ORIGINATION FORM

Proposed Revisions to a Standard Plans Index
(Please provide all information — Incomplete forms will be returned)

Index Number: 700-120

Index Title: Enhanced Highway Signing Assemblies

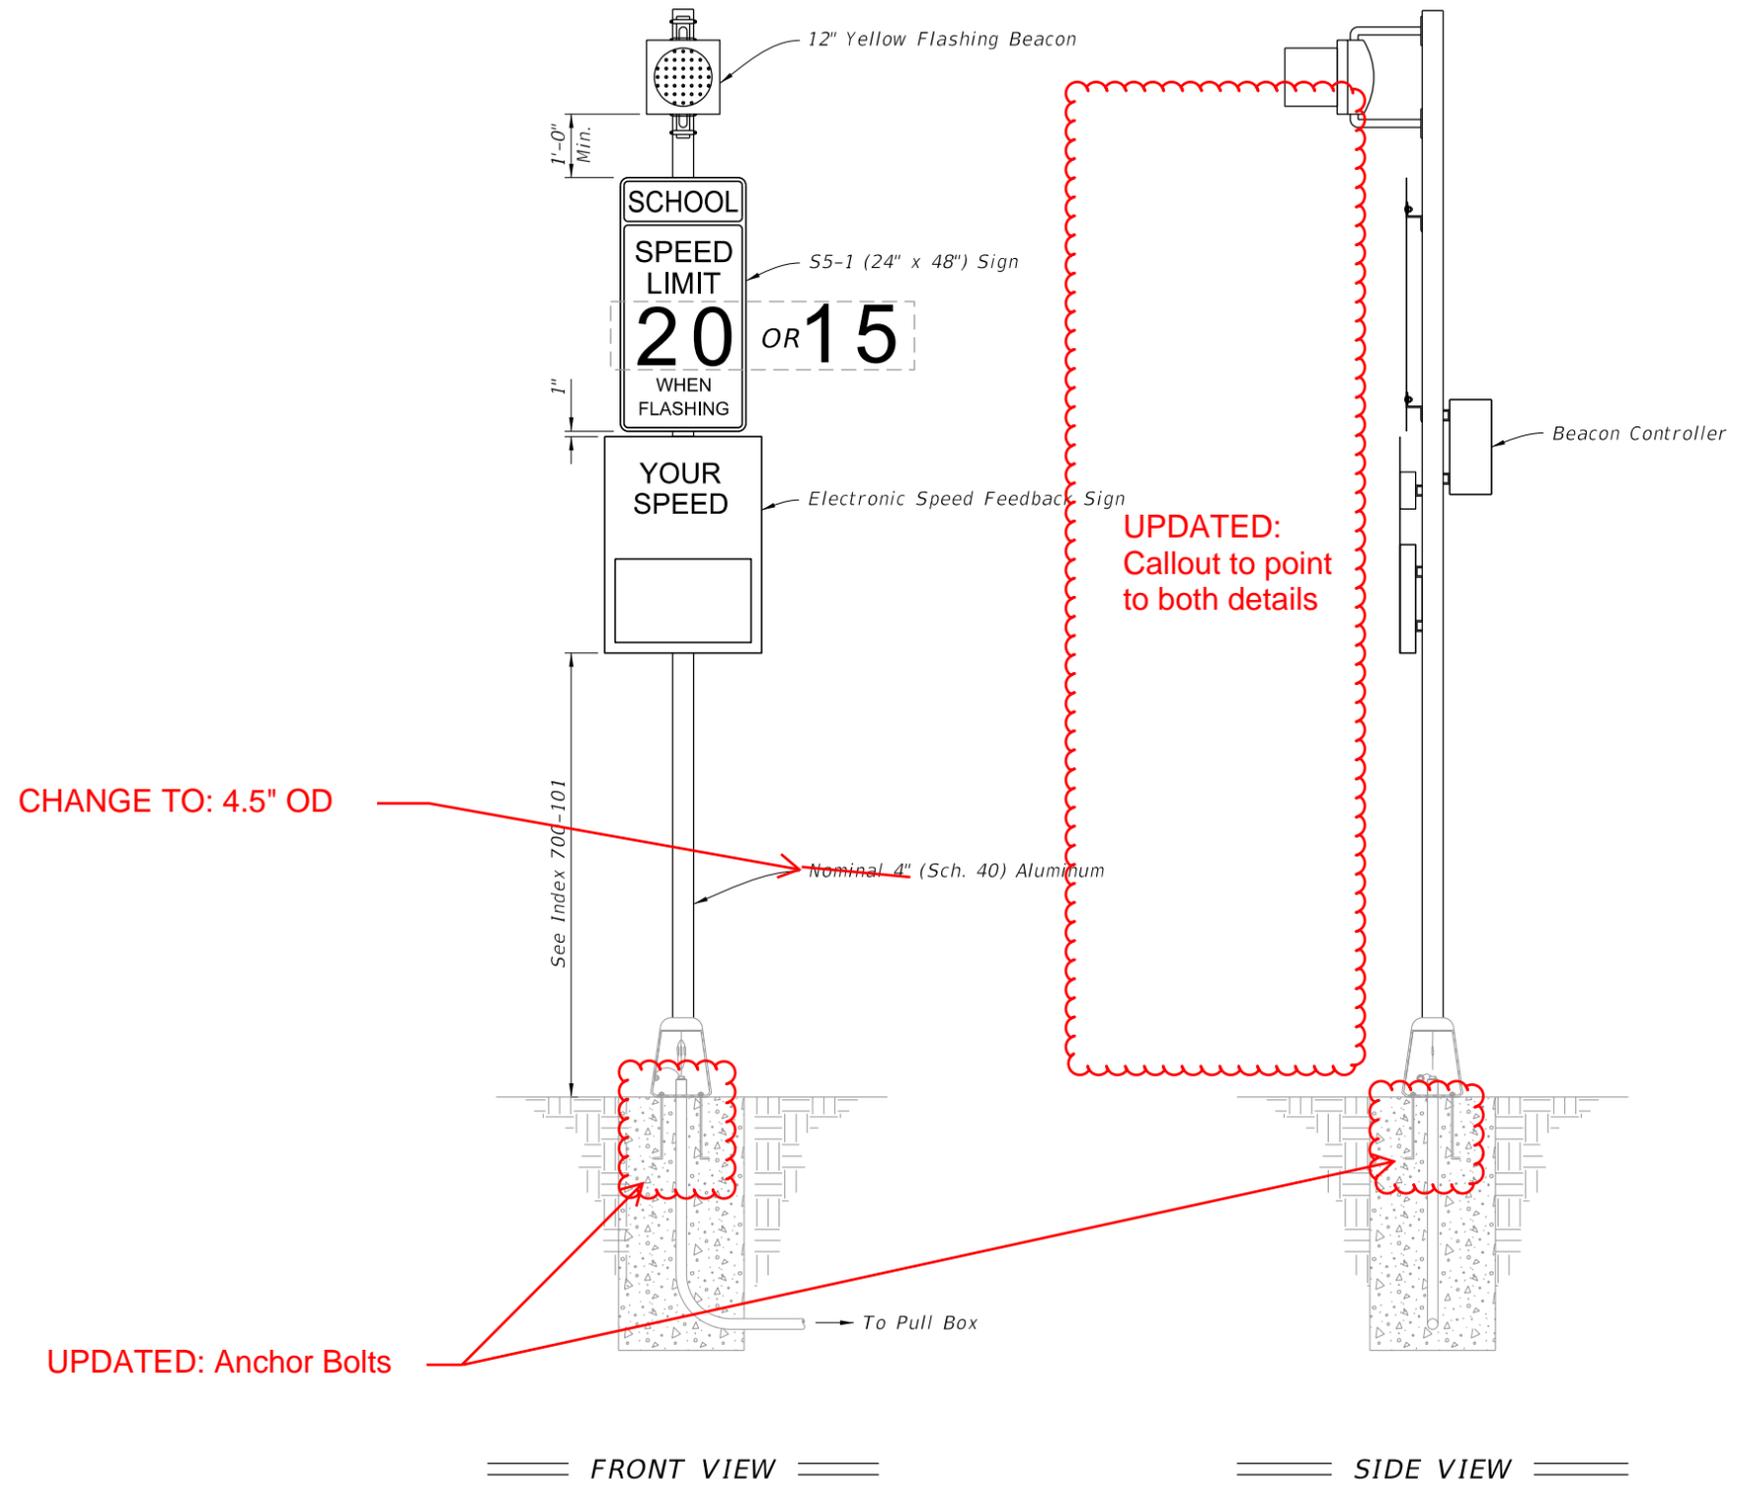
Sheets 3 through 11: Updated callouts to point to both details; Change all references "4" Nominal Aluminum Pole" to "4.5" OD Aluminum Pole; Updated anchor bolts; Added Note "Foundation reinforcement not shown".

ADDED NOTE:
Foundation reinforcement not shown.

ROADSIDE SIGN ASSEMBLY-4

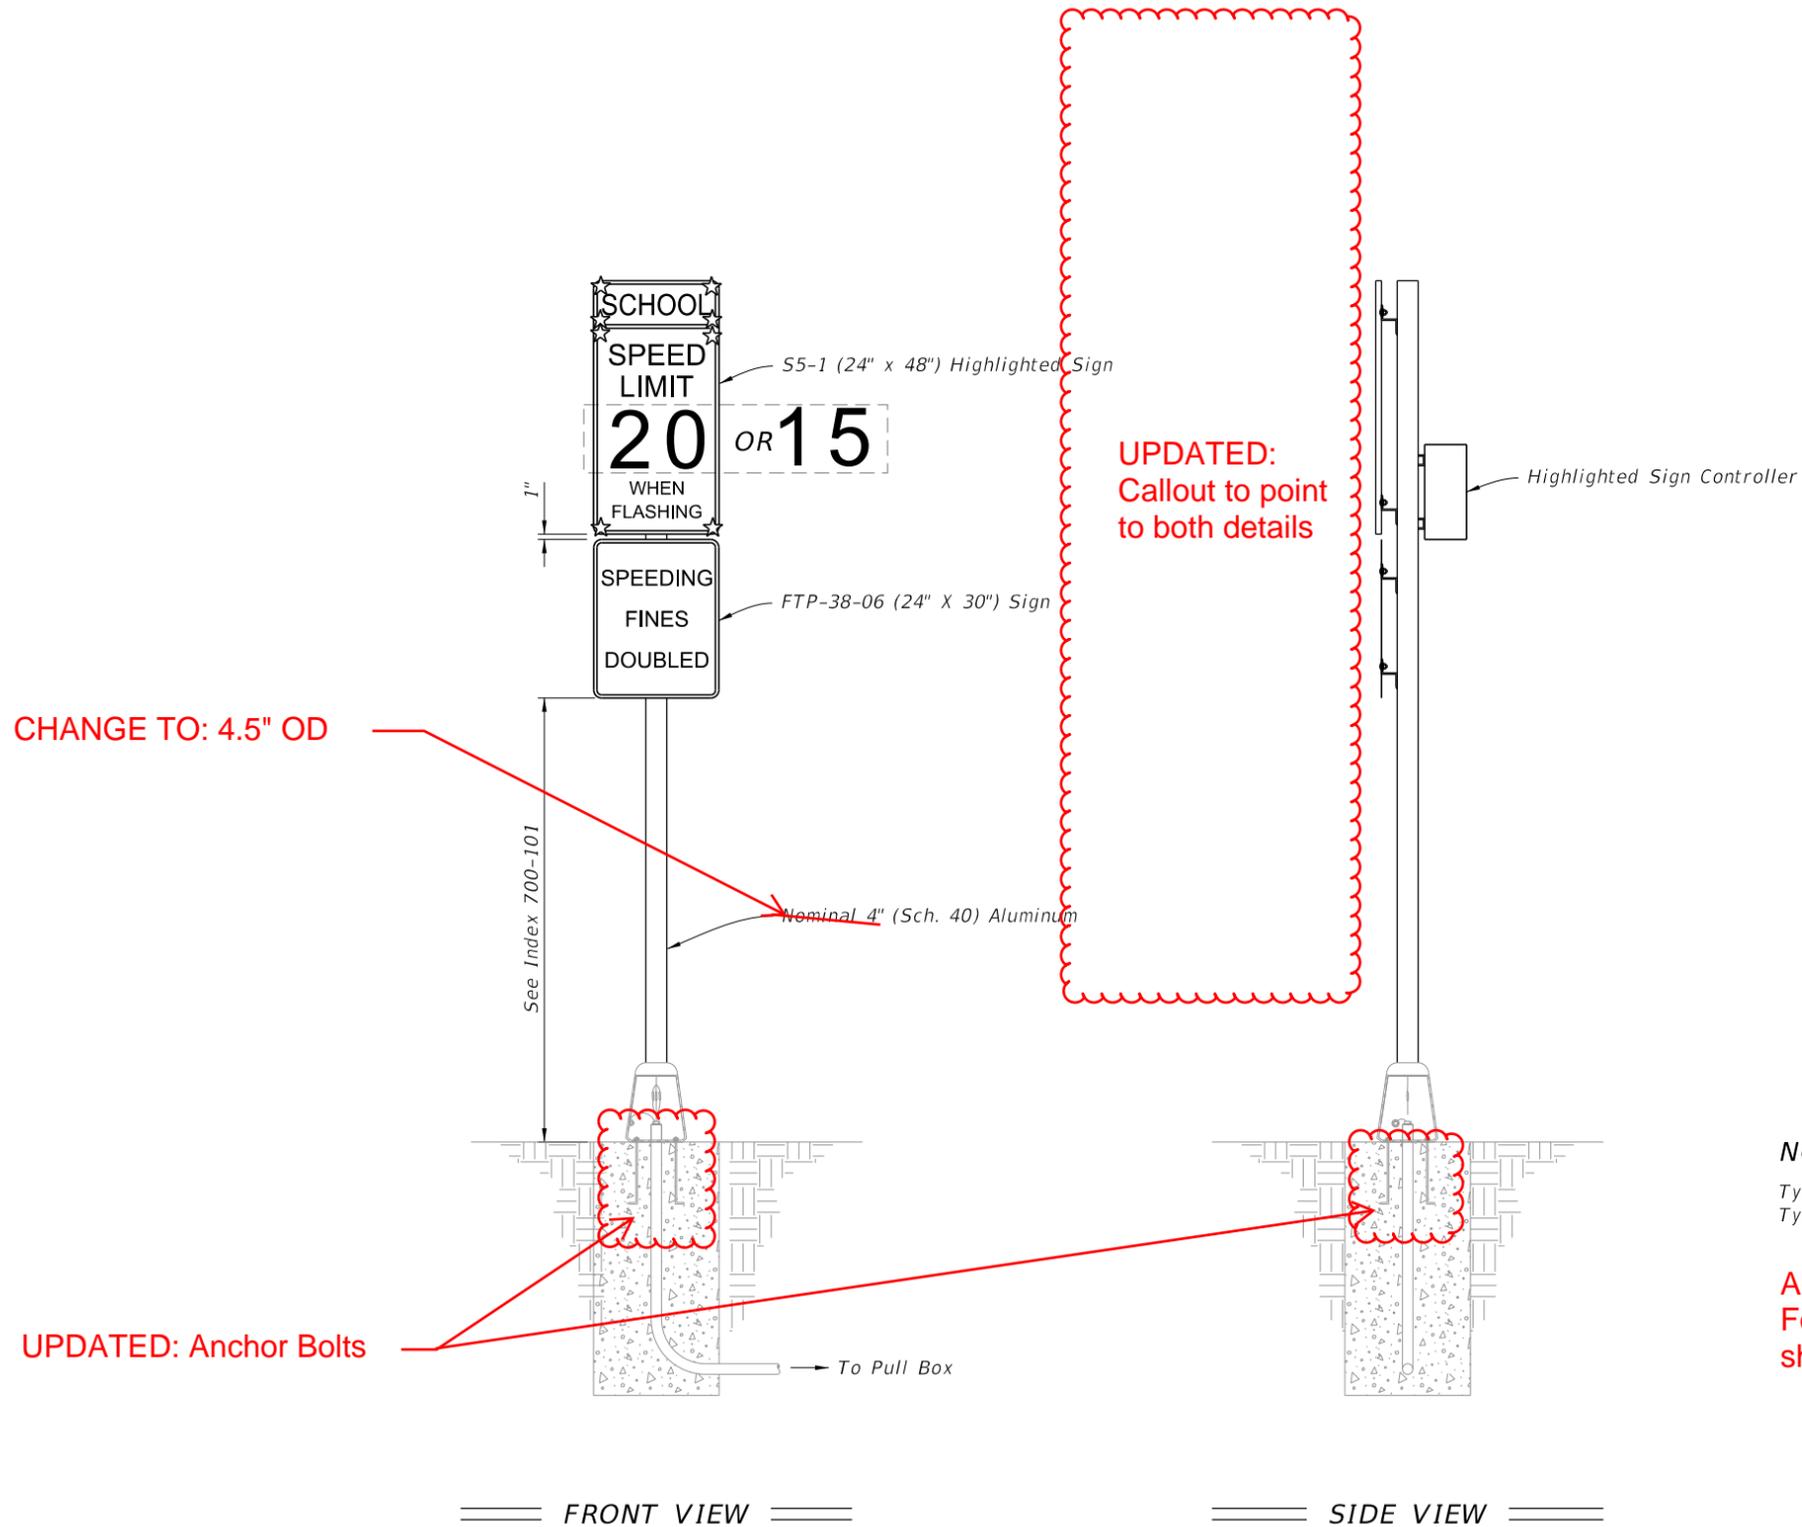
ADDED NOTE:
Foundation reinforcement not shown.

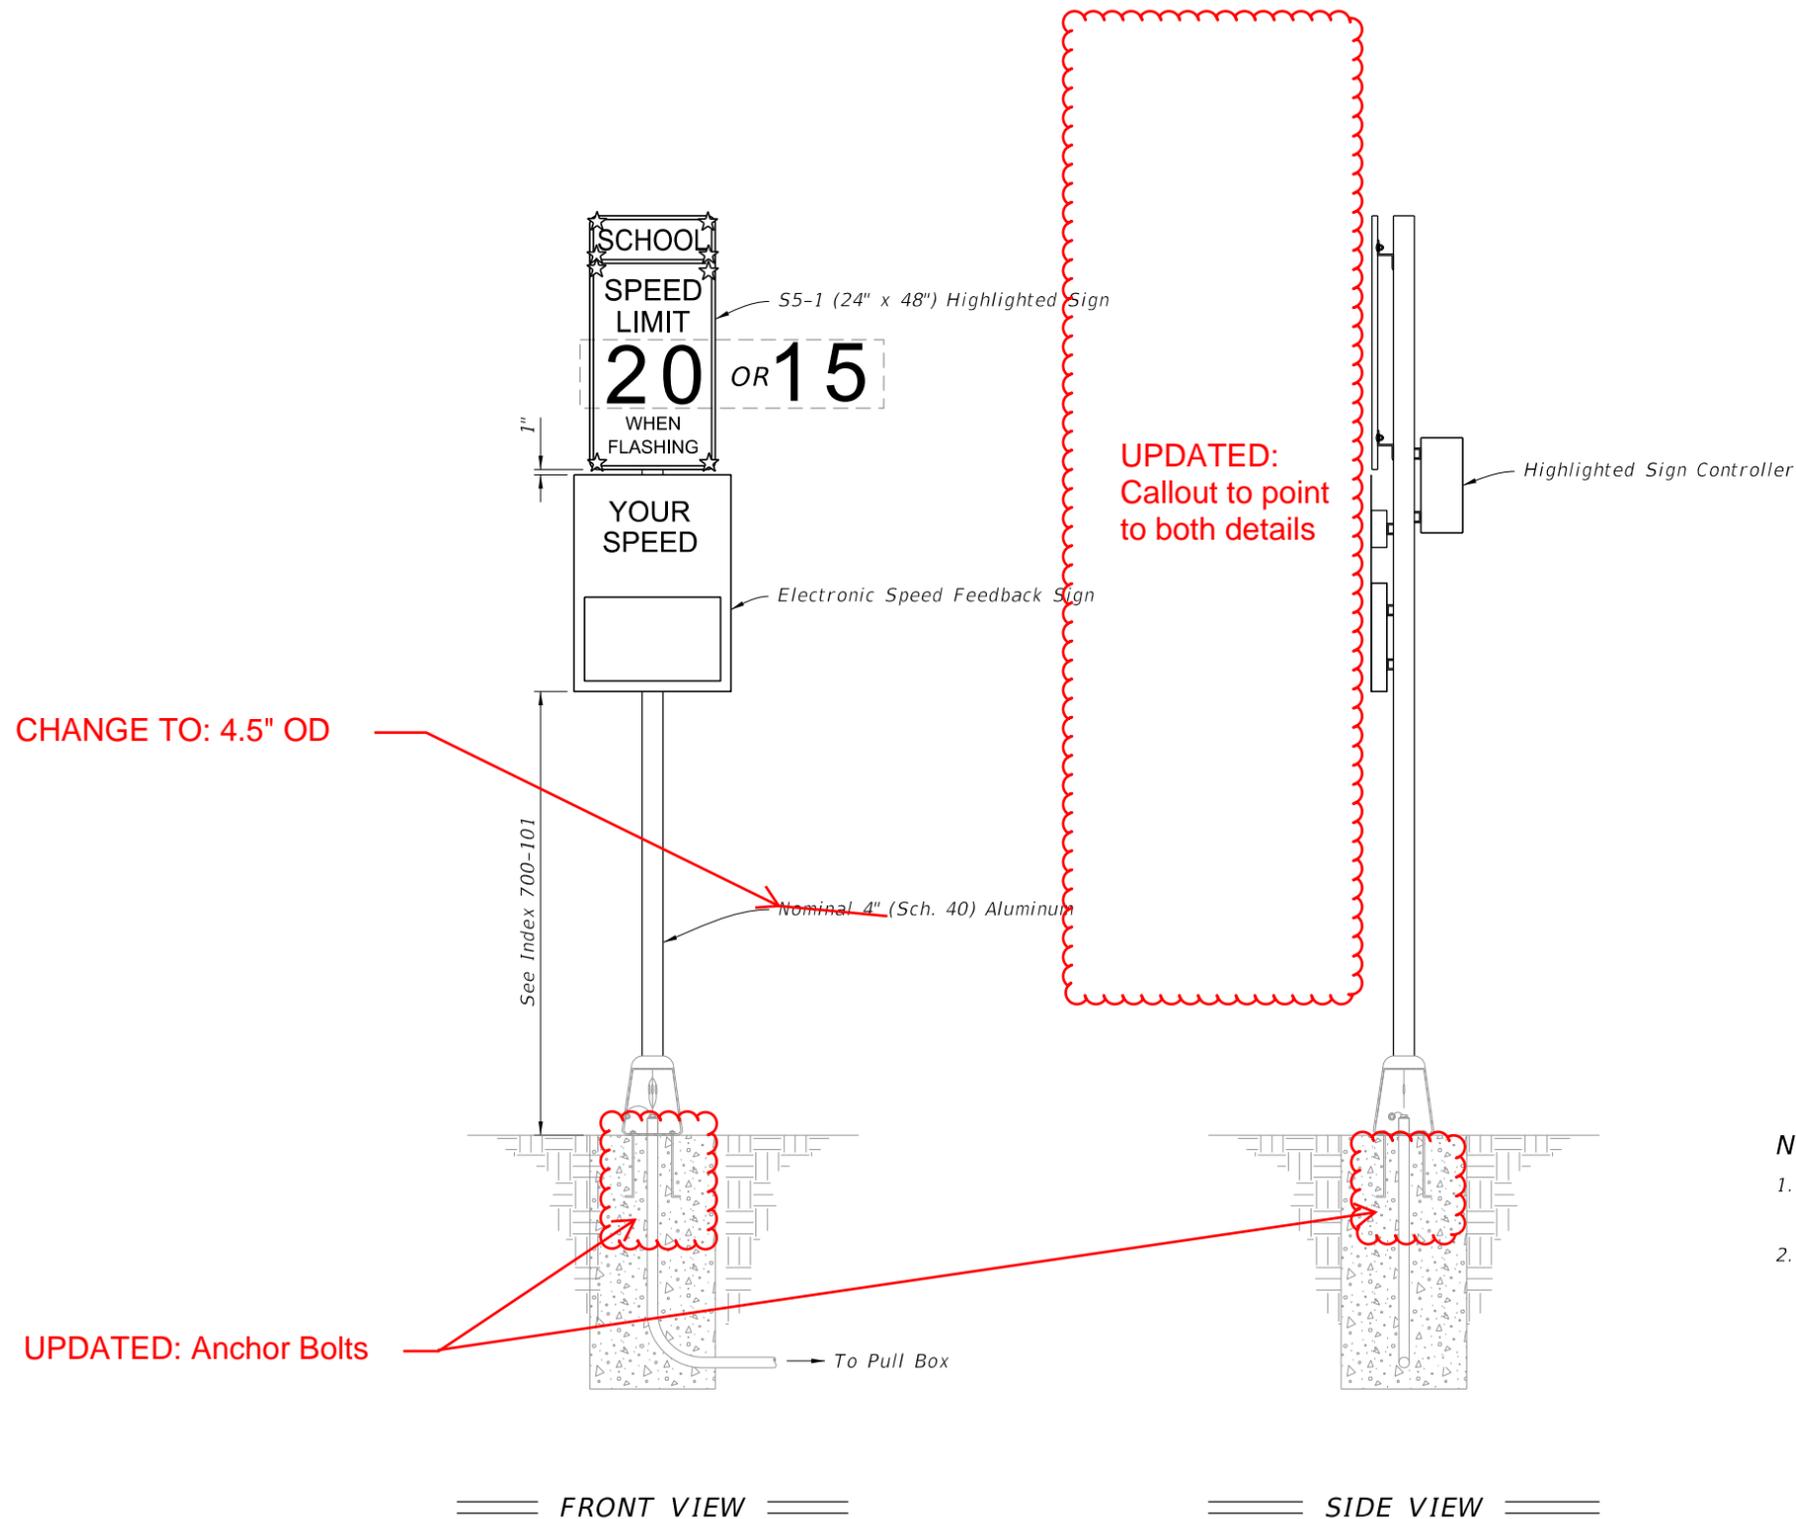
ADDED NOTE:

Foundation reinforcement not shown.

ROADSIDE SIGN ASSEMBLY-6

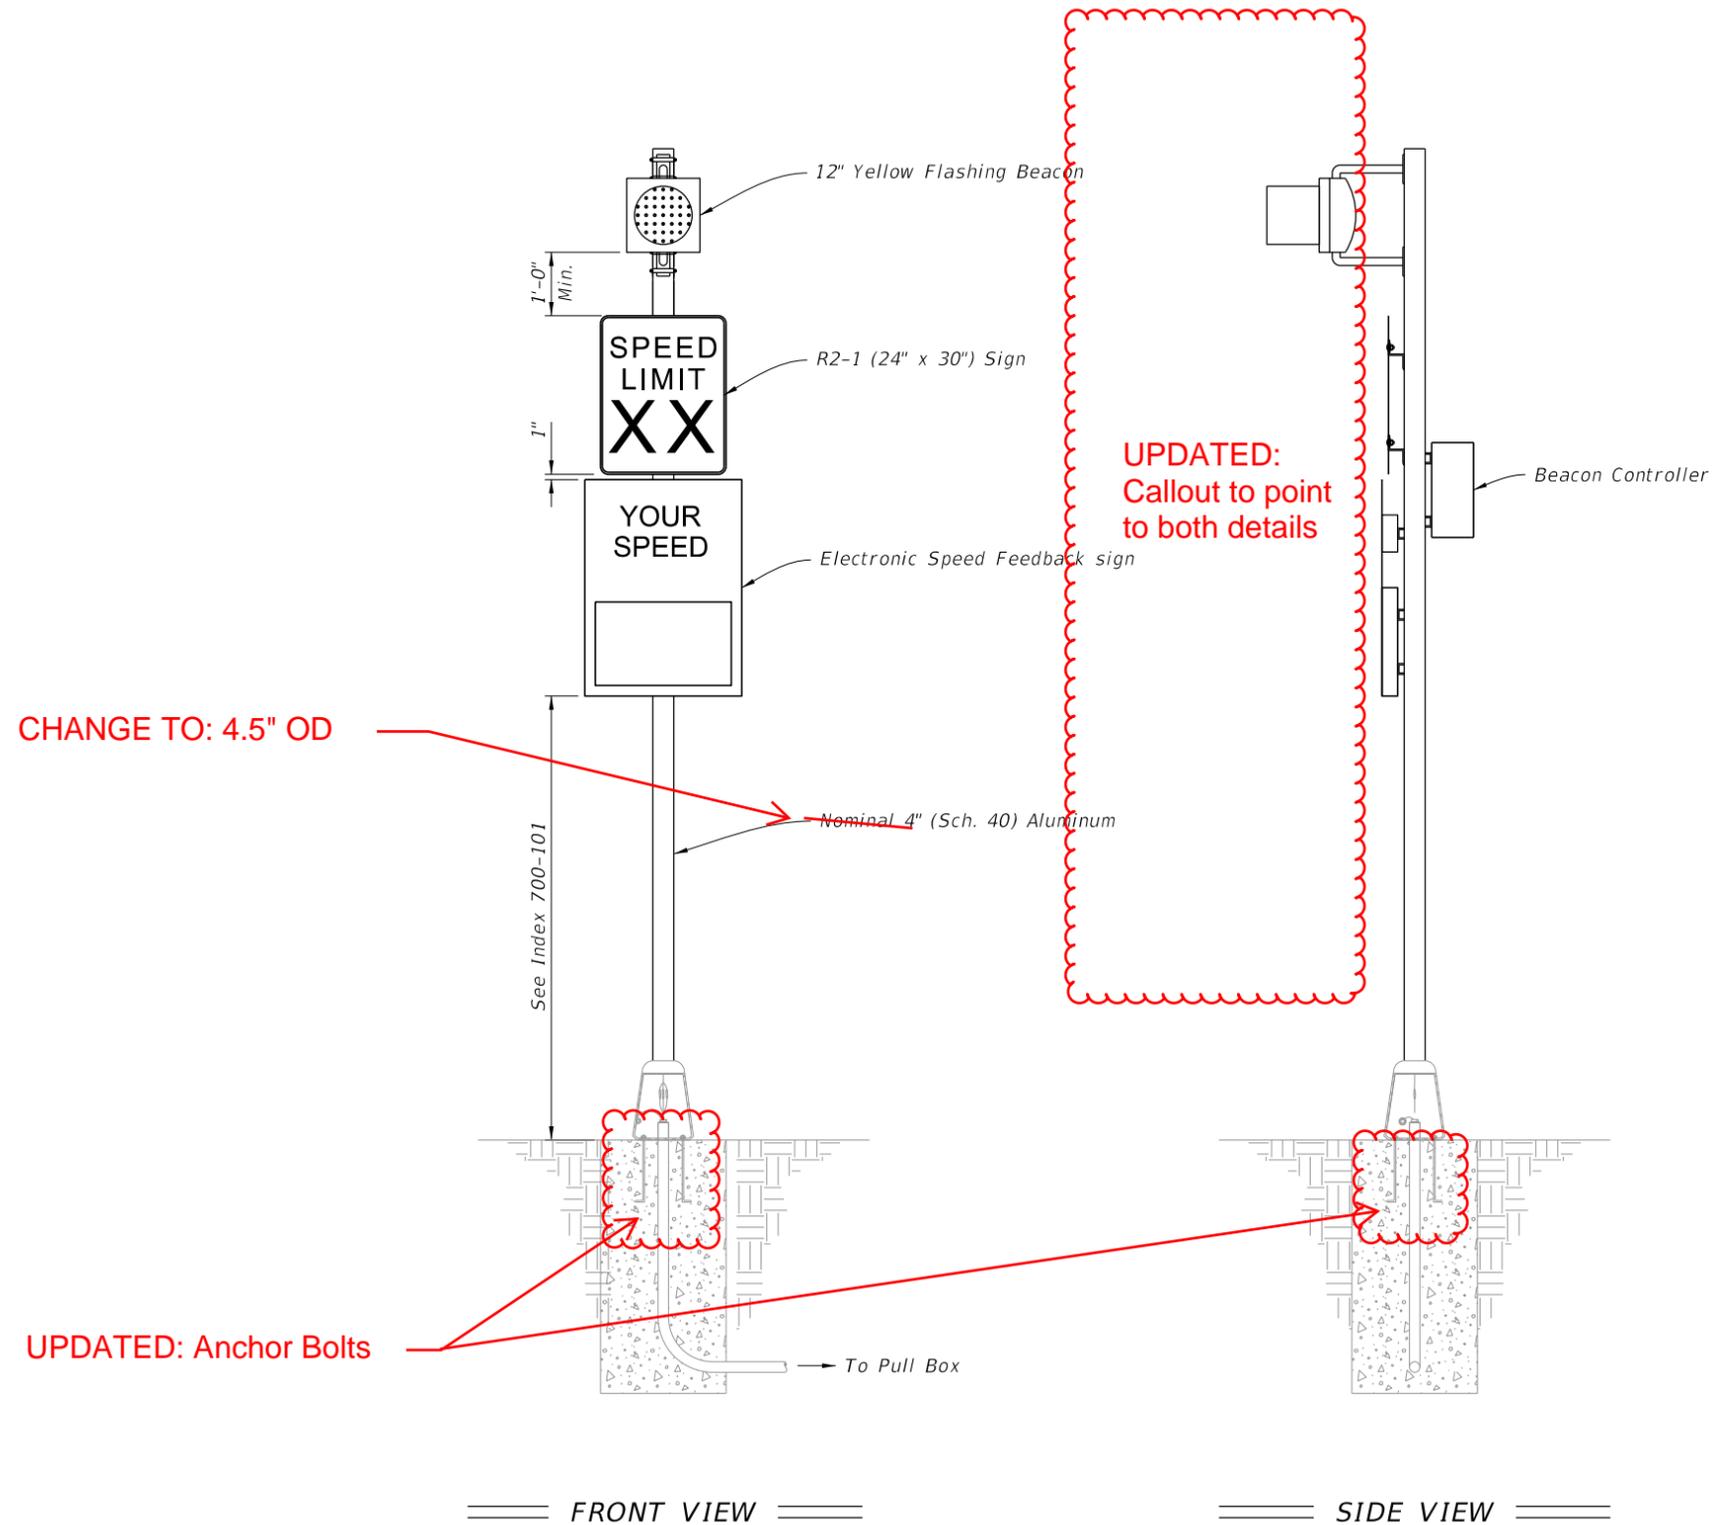
ADDED NOTE:
 Foundation reinforcement not shown.
